**Proposal
to introduce Grouping Criteria
for the approval
of replacement brake lining assemblies
for L-category vehicles
in UN Regulation No. 90**

submitted by ITALY

**82° GRRF
22 September 2016**

5.2.1.5. Replacement brake lining assemblies for vehicles of category L

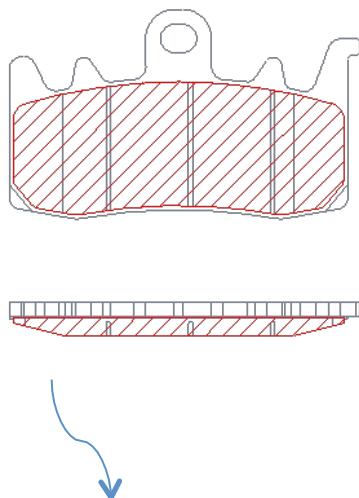
It is allowed the verification of a brake lining assembly deemed to be representative of a group of brake lining assemblies, grouped according to the criteria defined in Annex 7a.

The representative brake lining assembly is deemed to identify the most severe application.

Results obtained with that representative brake lining assembly are considered valid for all the brake lining assemblies belonging to the same group defined according to the grouping criteria as from Annex 7a.

At least one set **of the chosen** replacement brake lining assemblies, representing the type of lining to be approved, shall be installed and tested in at least one vehicle which is representative of the vehicle type for which approval is sought, according to the prescriptions of Annex 7 and shall satisfy the requirements stated in this annex. The representative vehicle(s) shall be selected from among the application range using a worst case analysis⁴.

Group	Brake lining area [cm ²]
A	≤ 15
B	$> 15 \leq 22$
C	> 22

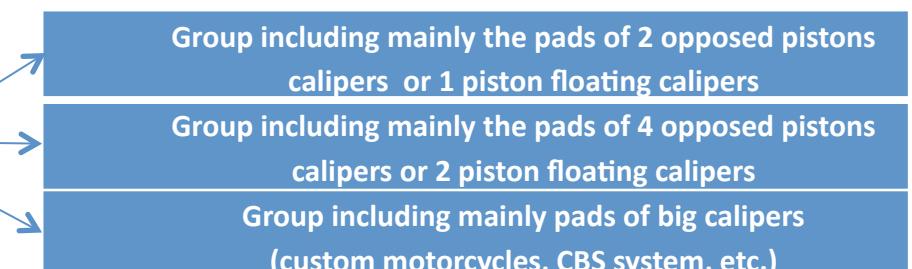
- a. According to the individual **friction material** of the brake lining (i.e. Organic, Sintered)
- b. Depending on the **area** of the friction material area of the brake lining assembly operated by the piston/pistons of only one side of the brake caliper

Slots and chamfers are not taken into account: their presence is provisional due to wear.

The total area is used to simplify the calculation, inevitable with so many different applications and initial shapes.
